Report for An Bord Pleanála

Appeal against Decision to Refuse Fire Safety Certificate

37 Harcourt Street, Saint Kevin's, Dublin 2

Client: An Bord Pleanála
An Bord Pleanála Ref: 307351-20
Our Ref: ABP_R009_Issue 1
Date: 4th March 2021

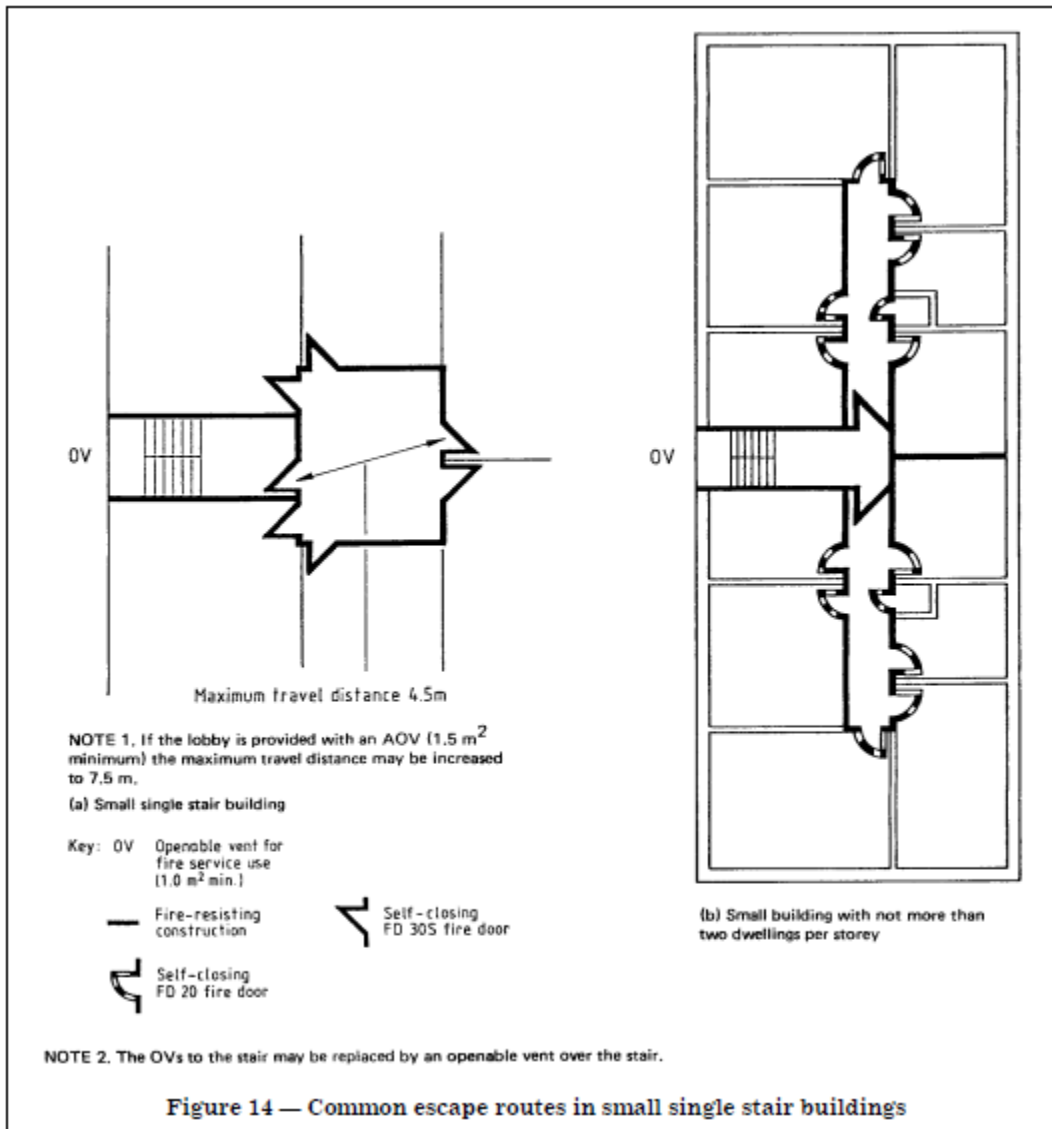
Assuming that the building (including Lower Ground and Ground floor are existing apartment use as per section 5.41 (j) the stairway serving the Lower Ground level should be separated from the upper storeys by 60 minutes fire resisting construction and FD30S doorsets. It is noted that this arrangement is currently not achieved. There is no separation between the entrance to Apartment 6 and the Lower Ground stair.

BS 5588 Part 1: 1990 AMD 2004 gives recommendations for apartment buildings. Figure 14 shows the recommendations for the common escape routes in small single stair buildings (<11m).

It is noted that without a lobby to the stair, a maximum of two dwellings per storey with protected hallways are allowed. It is noted that in 37 Harcourt Street there is no lobby protection to the stair, the apartments are provided with protected entrance hallways but there are three apartments per floor and the topmost floor is over 11m (if marginally). Therefore, the current proposed layouts do not comply with the recommendations of BS 5588 Part 1: 1990 AMD 2004 on a number of issues. A sufficient argument to justify these deviations from the recommendations of the code of practice has not been presented.
